Proposed Standard Plan Changes.

July 2, 2015

PART III

Standard Plans New Request

STATE OF NEVADA
DEPARTMENT OF TRANSPORTATION
FAST PACKAGE F
CABINET IDENTIFICATION CODE
ITS DETAIL

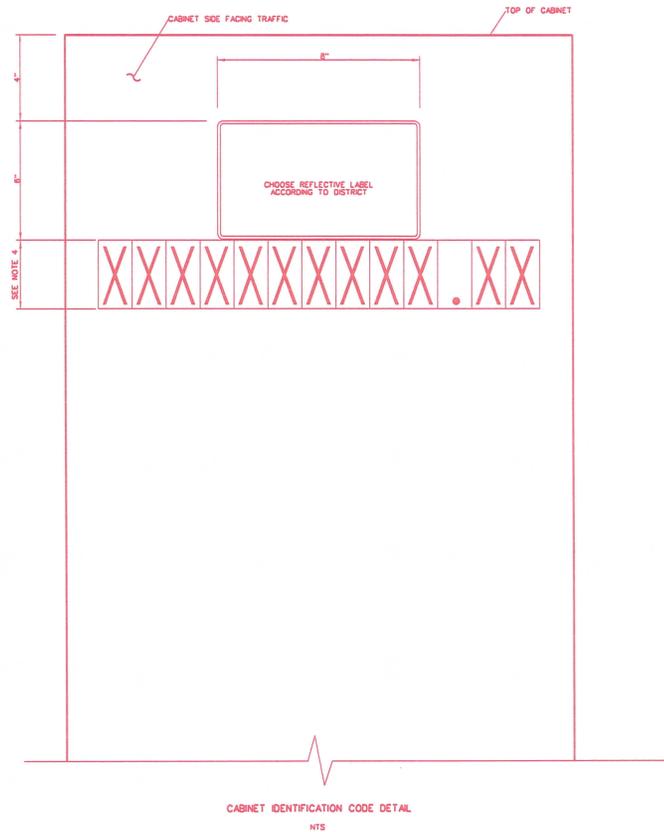
Have updated sheet

STATE OF NEVADA
DEPARTMENT OF TRANSPORTATION
FAST PACKAGE
TRANSFORMER CABINET AND FOUNDATION
ITS DETAIL

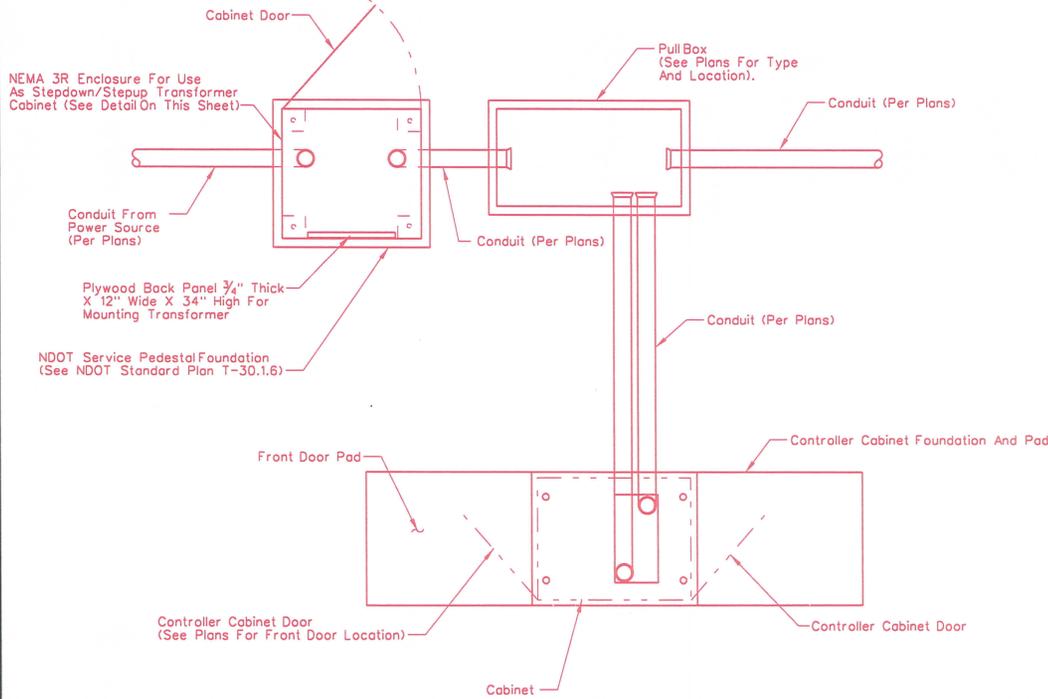
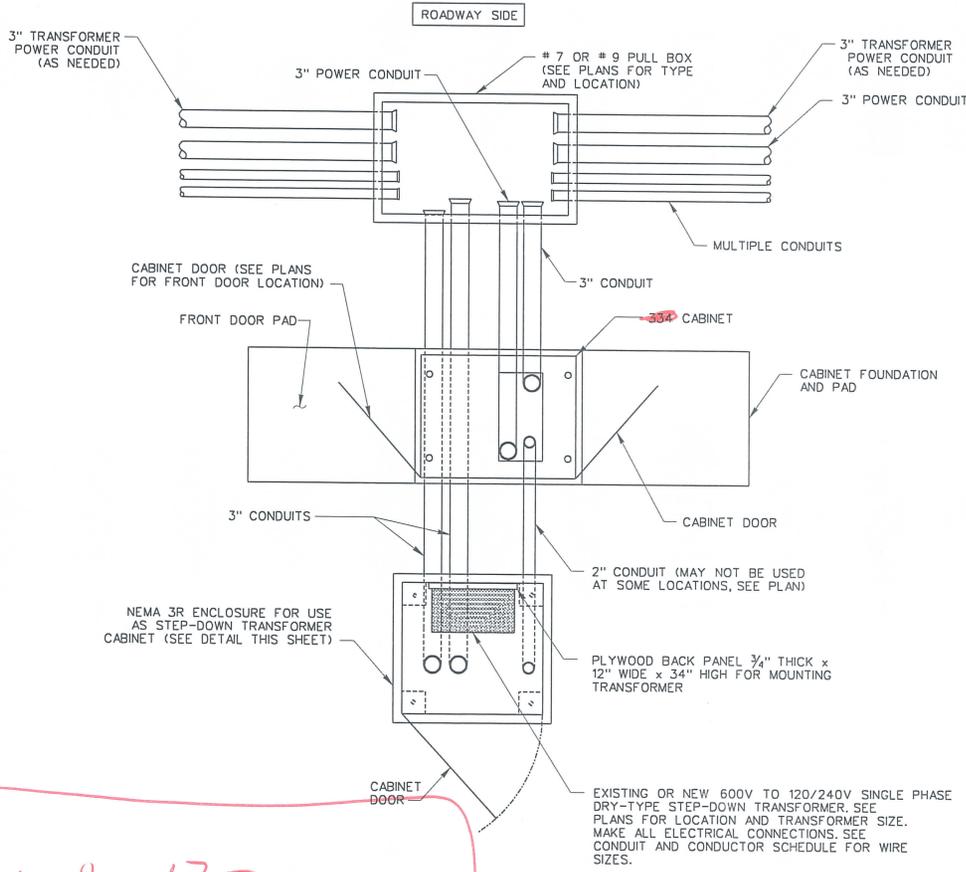
Comments: GIVE BETTER LAYOUT BETWEEN STEP UP
STEP DOWN TRANSFORMERS TO INCLUDE
WIRING DIAGRAM
ADD SHEETS AFTER T-30.1.6

ADD

**NO. 7 PULL BOX
MODIFIED TYPICAL
INSTALLATION**

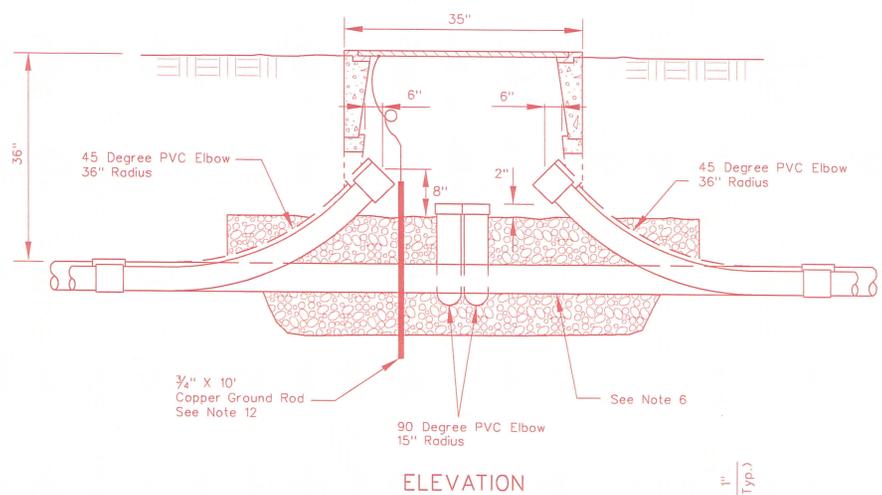
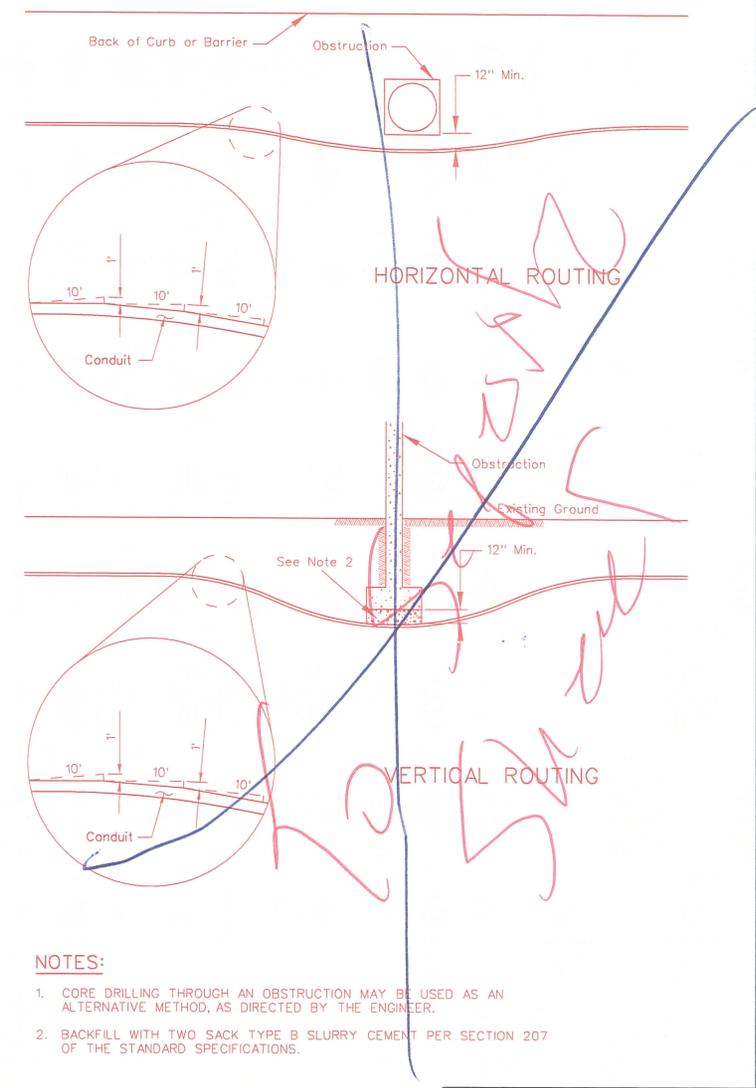
Comments: SHOWS CONDUIT SWEEPS AND INSTALL
DETAILS
INCLUDED SHEETS FOR COMBINED ONE
SHEET TO BE PLACED IN
FRONT OF NO. 9 MODIFIED DETAILS.

TYPE 2 DYNAMIC MESSAGE SIGN

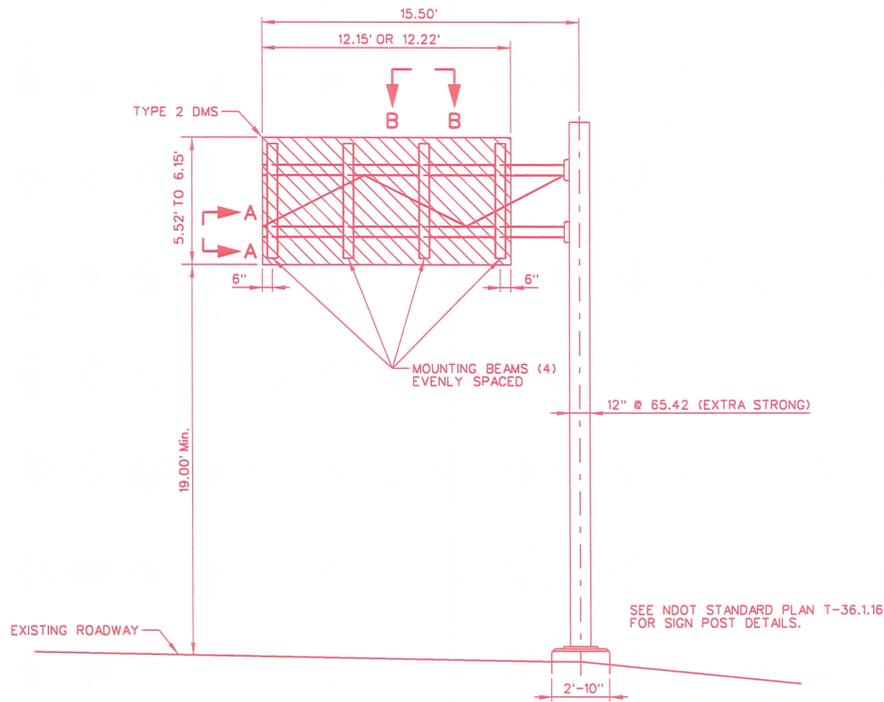
Comments: USED ON RANCHO ITS PROJECT (LPA)
AND STATEWIDE ITS PROJECT (DISTRICT
CONTRACT) ADD AFTER CURRENT SHEET T-88
SEE ATTACHED

NEVADA DEPARTMENT OF TRANSPORTATION	
PERMANENT PAVEMENT MARKINGS AIRPLANE SPEED MONITORING SITES	
Signed Original On File	T-38.1.6 (634)
CHIEF SAFETY/TRAFFIC ENGR.	ADOPTED 8/06 REVISION

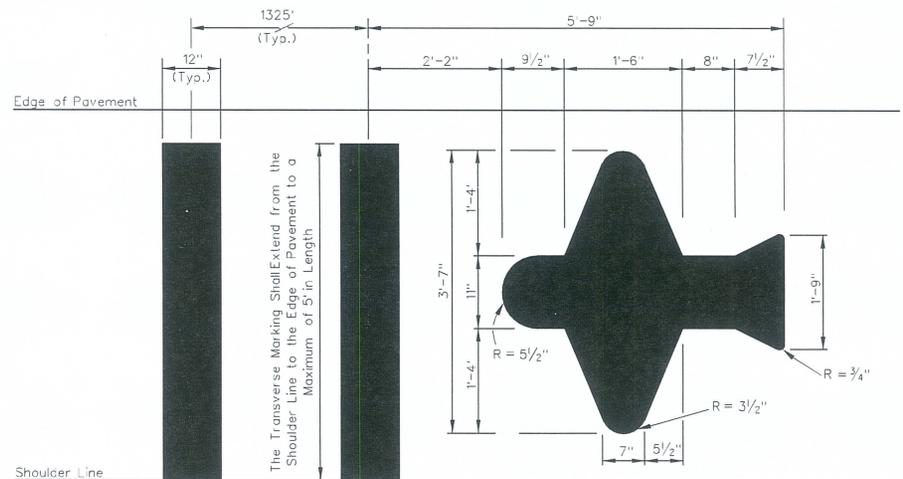
Delete this sheet
